## Executive Director's Recommendation

<b>PROJECT</b> <b>Proposed Site for the FDR Prayer Plaque</b> World War II Memorial The National Mall Washington, DC	<b>NCPC FILE NUMBER</b> 7727
	<b>NCPC MAP FILE NUMBER</b> 00.00(73.10)44248
<b>SUBMITTED BY</b> United States Department of Interior National Park Service	<b>APPLICANT'S REQUEST</b> Approval of comments on site selection
<b>REVIEW AUTHORITY</b> Per 40 U.S.C § 8905	<b>PROPOSED ACTION</b> Approve comments as requested
	<b>ACTION ITEM TYPE</b> Staff Presentation

# President Franklin D. Roosevelt Prayer Plaque World War II Memorial

Site Selection Review

# Project Location: Site Location Alternatives

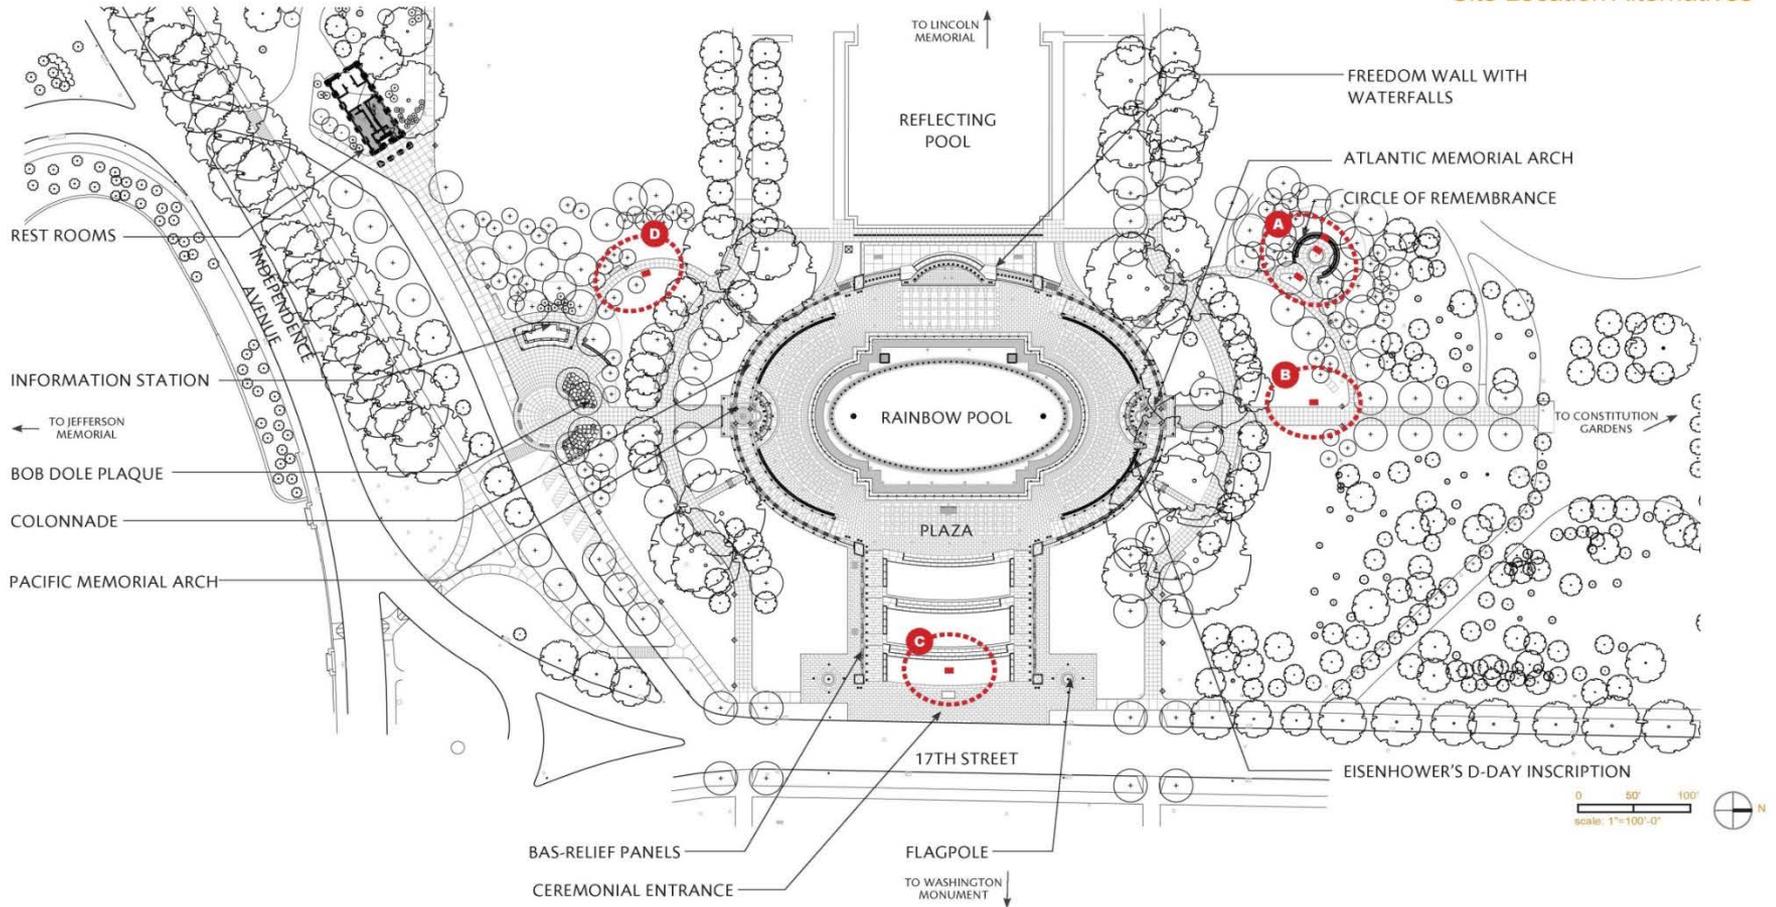
**Supports** selecting Site A, the Circle of Remembrance, as the preferred location for the President Franklin D. Roosevelt prayer plaque or inscription.

**Notes** that Site A maintains a contemplative character created by existing vegetation, a low fieldstone wall, and separation from roadway traffic. The Circle of Remembrance is located in close proximity to existing thematically relevant memorial elements, the Atlantic Arch and Eisenhower's D-Day inscription. Additionally, this location will not impede existing circulation patterns or activities since it is not co-located with an existing pathway or assembly space, as are alternative Sites B, C, and D.

**Does not support** Site C due to its location along the centerline of the Mall, connecting the Washington Monument to the Lincoln Memorial, and because of its use as an outdoor assembly space, which is in contrast to the contemplative character desired for the prayer plaque site.

**Recommends** that the sponsor develop a range of alternative designs and locations within the area of the Circle of Remembrance. Alternatives should include integrating the inscription with landscape furnishing elements, such as retaining walls or benches, as well as stand-alone elements. The design should protect existing viewsheds to the National Mall, including views to the World War II Memorial primary precinct, the Washington Monument, and Constitution Gardens. Additionally, the plaque should be installed in a manner that is complementary in scale and material to the Circle of Remembrance.

**Site Location Alternative A:  
Circle of Remembrance**

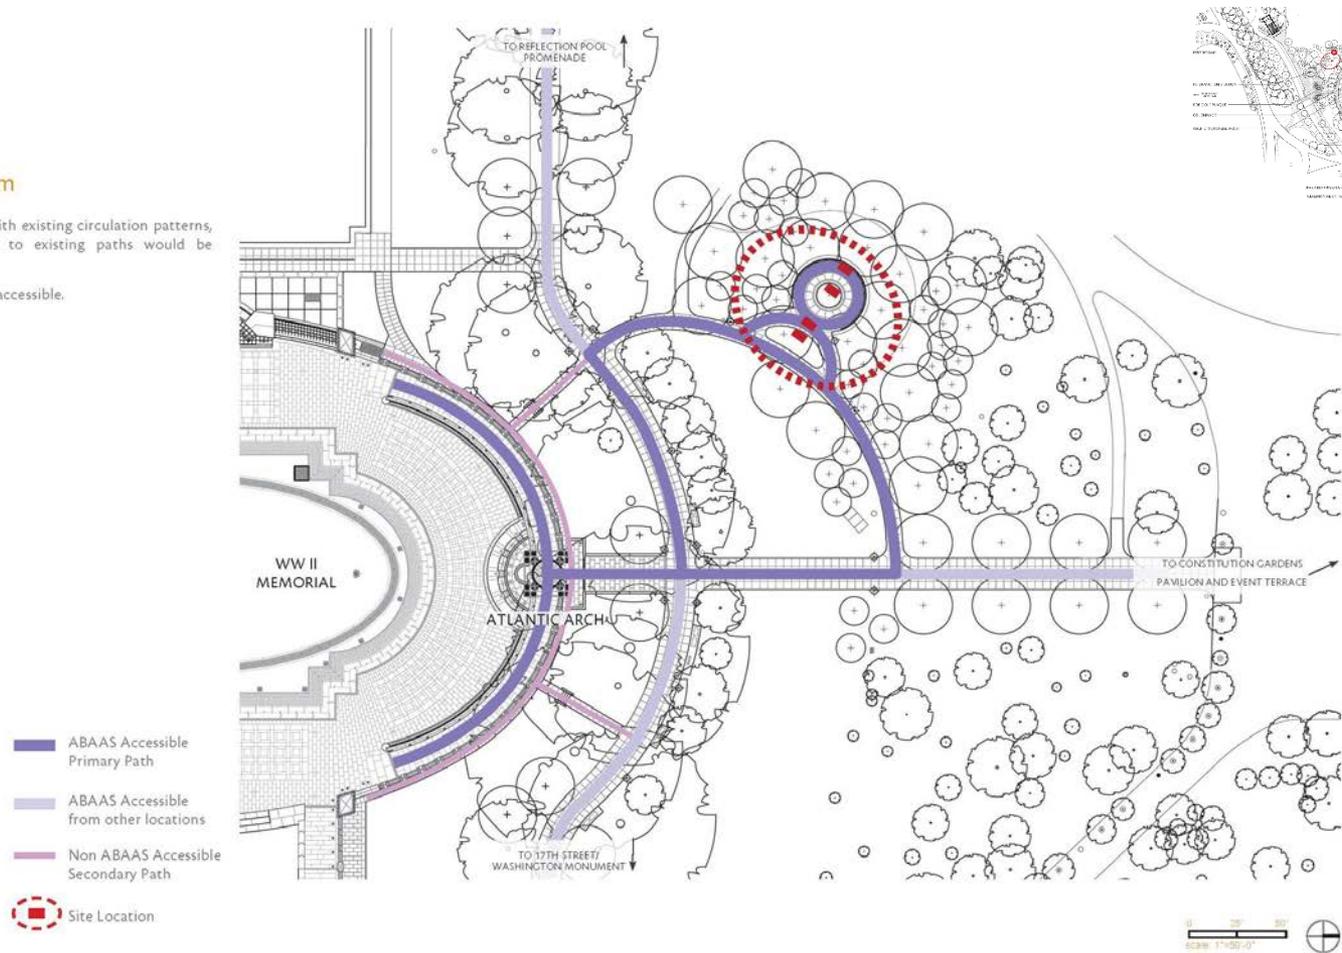
This site meets all of the CWA site selection guidance and all of the NPS site selection criteria (see matrices on pages 24 and 25 of this package). Site A is located in close proximity to the Atlantic Arch and President Eisenhower's D-Day inscription. Of the four sites, this location holds the most promise for contemplation and peaceful reflection. The intimate garden setting is a place where smaller groups of 30 to 50 people could gather, away from the bustling crowds in the main plaza. Located to the north of the World War II Memorial and adjacent to Constitution Gardens, this site is accessible by public transportation stops located along Constitution Avenue. NPS has commented that this site is not currently as well utilized as was originally envisioned. NPS's Section 106 initiation letter to the District of Columbia State Historic Preservation Officer (DC SHPO) also indicates that the Circle of Remembrance is NPS's preferred site.

Staff supports locating the FDR prayer plaque at Site A and encourages the applicant to consider how changes to the site could impact its character. A new element may activate the currently underutilized gathering space at the Circle of Remembrance. The new addition of the prayer plaque and associated events could help to draw more visitors to this area of the park and offer a different type of gathering space as a counterpoint to the main plaza. As identified by the applicant in Option 1, a design approach that integrates the words of the FDR prayer into landscape furnishing elements, such as retaining walls, benches, or landscape seat walls, could improve the Circle of Remembrance and establish a material palette that is more similar to the World War II primary precinct. The design of new elements for the site of the Circle of Remembrance should be coordinated with future plans for Constitution Gardens and the Potomac Park Levee System.

## Potential Locations for the D-Day Prayer within the Circle of Remembrance

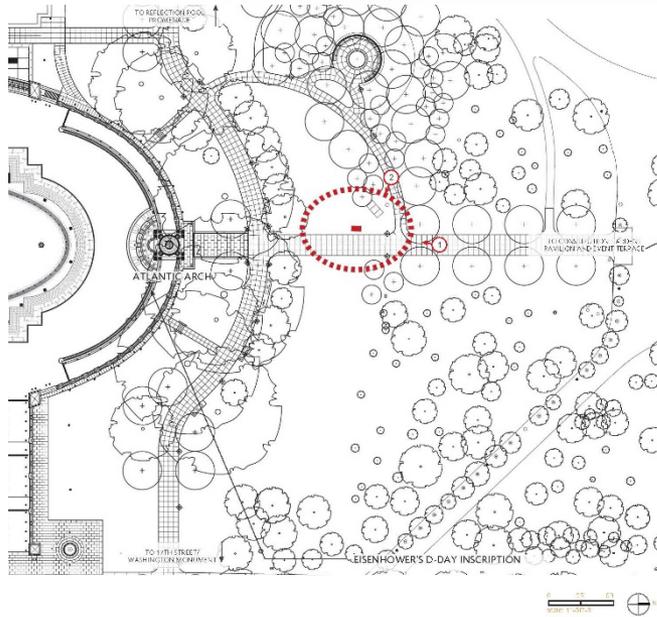
The applicant identified four options for the placement of the plaque within Site A (see map on page 17). These include:

- Option 1: Replacing existing wood benches (and possibly the fieldstone wall) with granite benches to match those in the primary Memorial precinct. The D-Day Prayer could be sited in the center of the bank of benches. In order to protect views from

Constitution Gardens, the benches and D-Day Prayer shall not be any taller than the existing fieldstone wall.

- Option 2: The D-Day Prayer could be sited within the central planter.
- Option 3: The D-Day Prayer could be sited within the planter at the entrance of the Circle of Remembrance.
- Option 4: The D-Day Prayer could be sited on the paving area at the entrance of the Circle of Remembrance.

At a future date, NPS will submit the plaque for approval. Staff recommends that **the Commission recommend that** the sponsor develop a range of alternative designs and locations within the area of the Circle of Remembrance that include integrating the inscription with landscape furnishing elements and stand-alone plaques. The design should protect existing viewsheds to the National Mall, including views to the World War II Memorial primary precinct, the Washington Monument, and Constitution Gardens. Additionally, the plaque or inscription should be installed in a manner that is complementary in scale and material to the Circle of Remembrance.

**Alternative B:  
Path Edge Northeast of the  
Atlantic Memorial Arch**

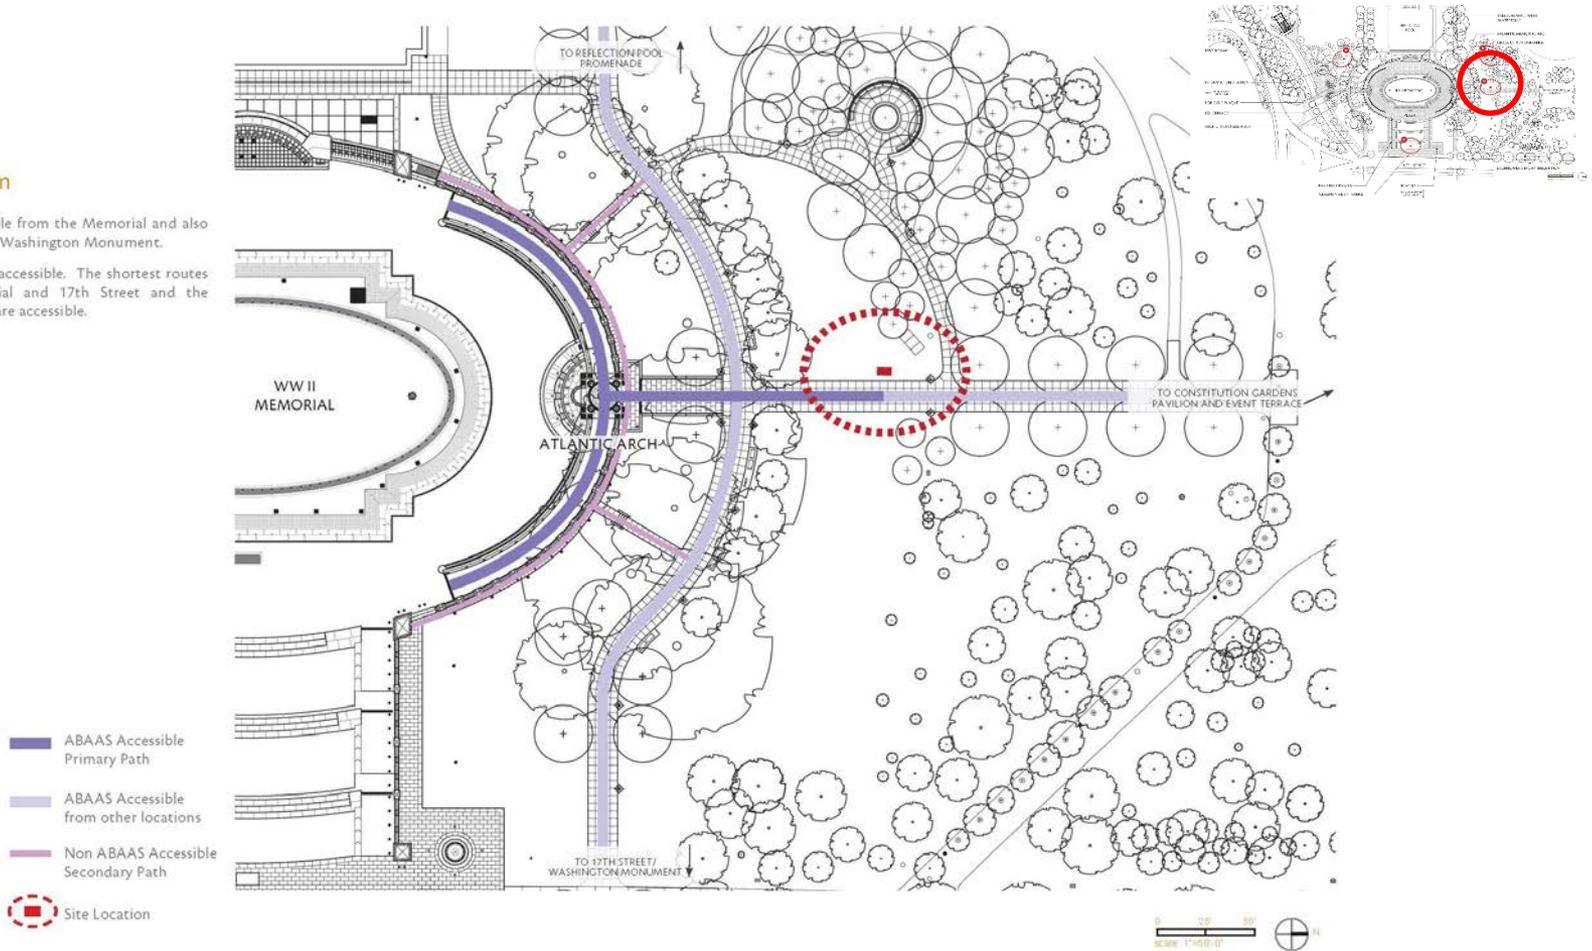
This site meets four of the five CWA site selection guidance and six of the ten NPS site selection criteria. Site B is located in close proximity to the Atlantic Arch and President Eisenhower's D-Day inscription. This site is a point along an existing 16' wide scored concrete path. Currently, there are no resting areas or benches adjacent to the potential plaque placement. The exposed nature of this site does not support the contemplative character desired for the prayer plaque location.

## Site Alternative C: Ceremonial Entrance

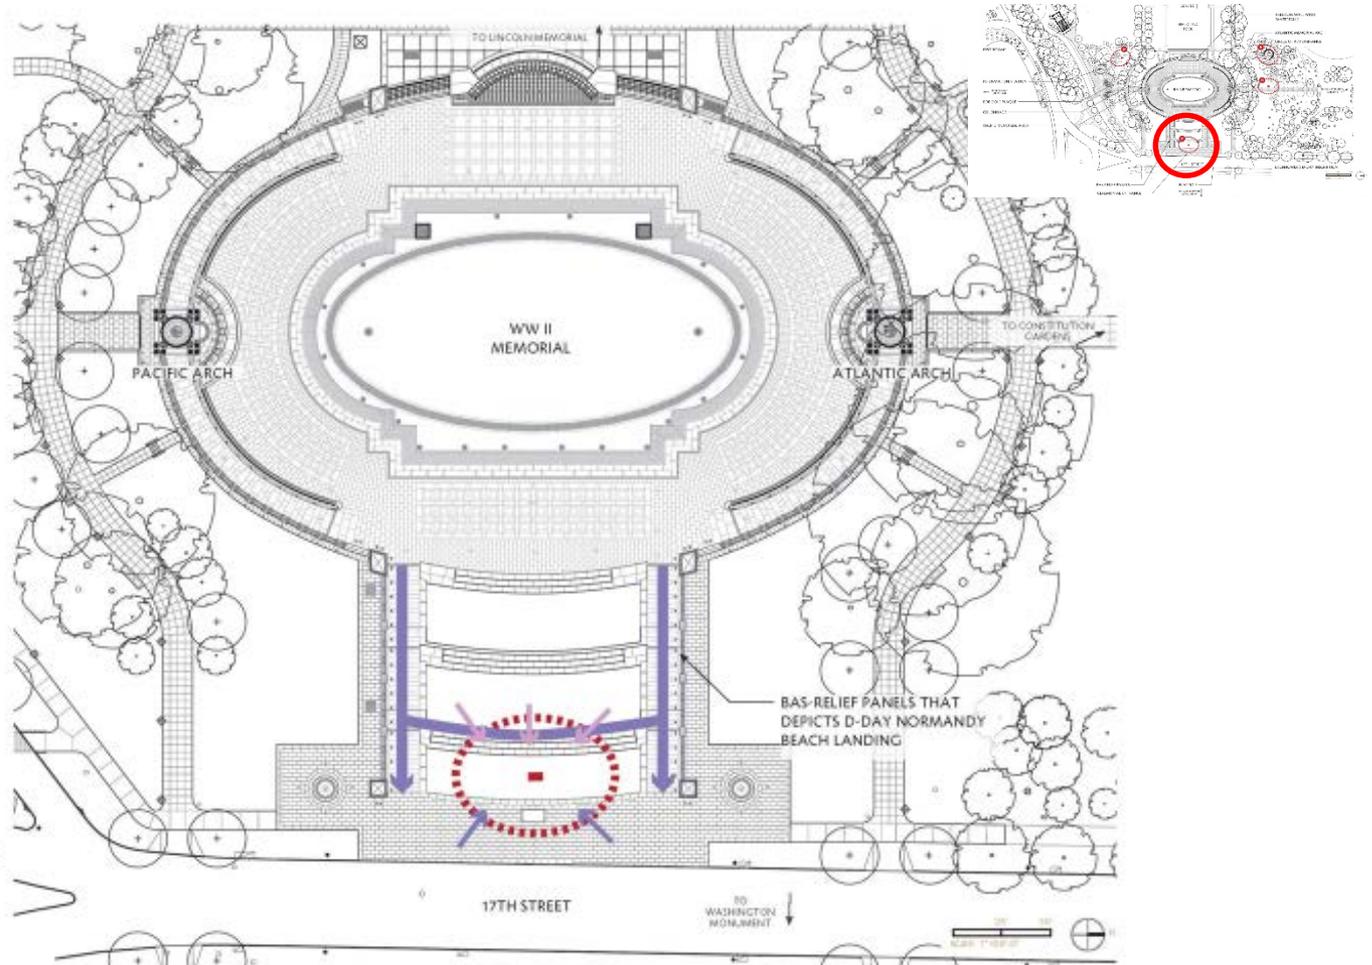
This site meets two of the five CWA site selection guidance and two of the ten NPS site selection criteria. Staff does not support the selection of Site C because of its location along the centerline of the Mall, the axis symbolically connecting the Washington Monument and the Lincoln Memorial. Furthermore, Site C's use as an outdoor assembly space, exposed nature, and bustling character do not support the contemplative character desired for the prayer plaque location. Furthermore, the potential plaque placement is positioned on an existing grass panel, which would require additional paths or pavement to make the plaque ABAAS accessible.

Site Alternative D:  
Path Edge Northwest of the  
Information Station

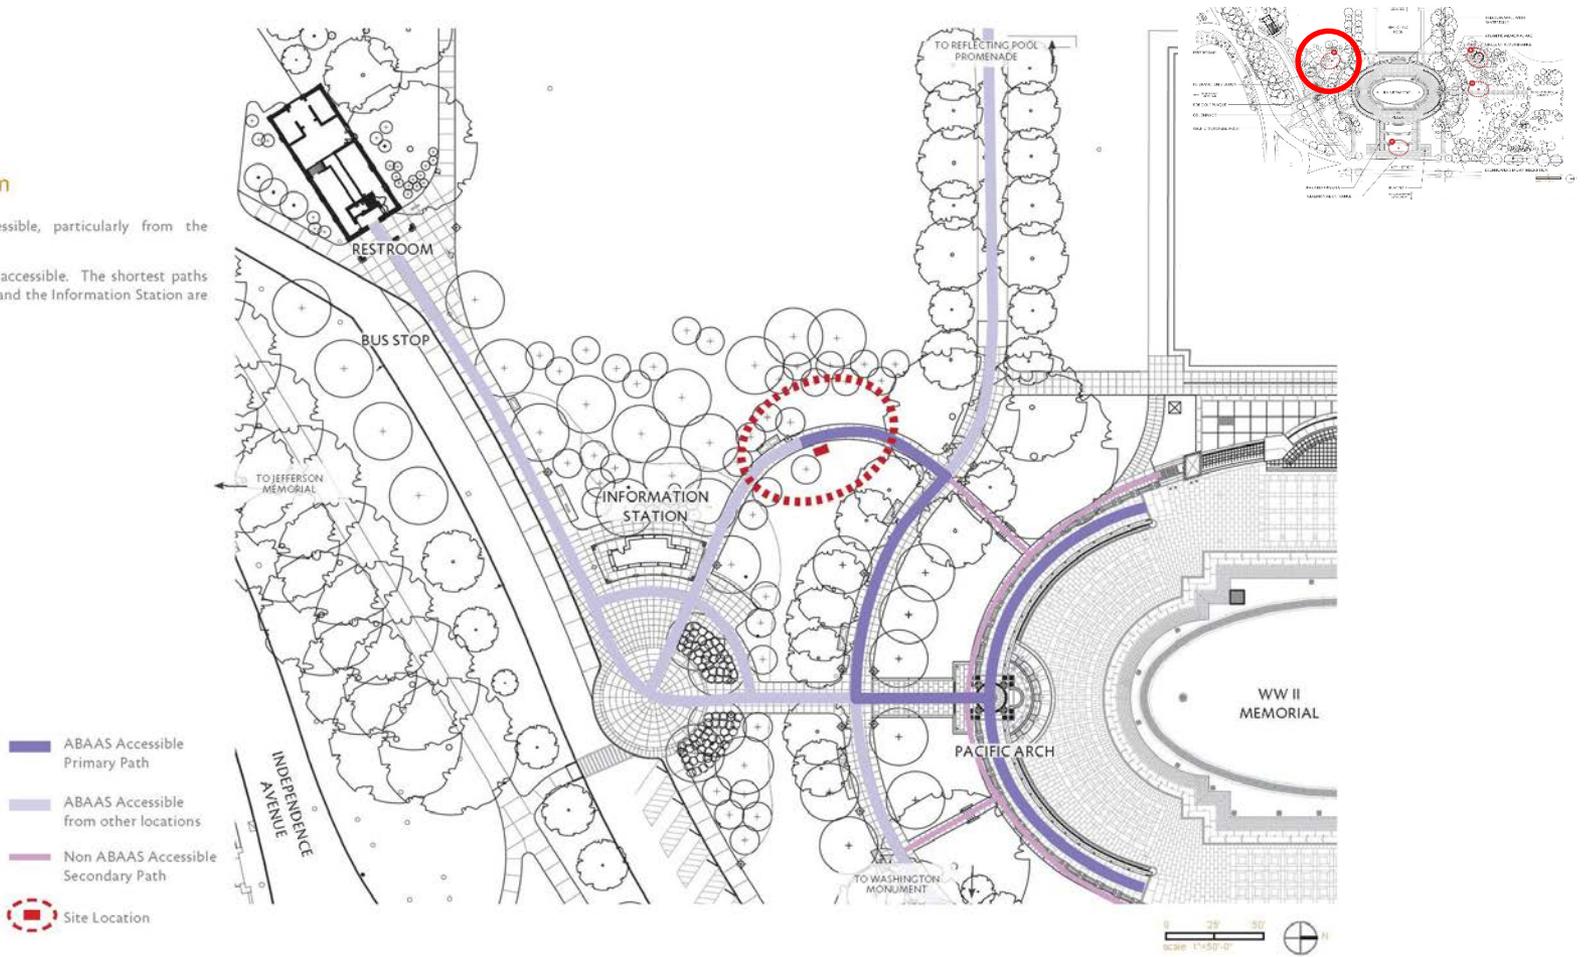
This site meets four of the five CWA site selection guidance and eight of the ten NPS site selection criteria. Site D is located furthest away from existing relevant subject material and is a point along an existing 8' wide path. Two benches are located on the opposite side of the path from the potential plaque placement. The narrow width of the existing path could lead to congestion for pedestrian circulation. While the site is well screened by vegetation, it is subject to considerable

ambient noise from the nearby tour bus drop-off. The loud nature of this site does not support the contemplative character desired for the prayer plaque location.
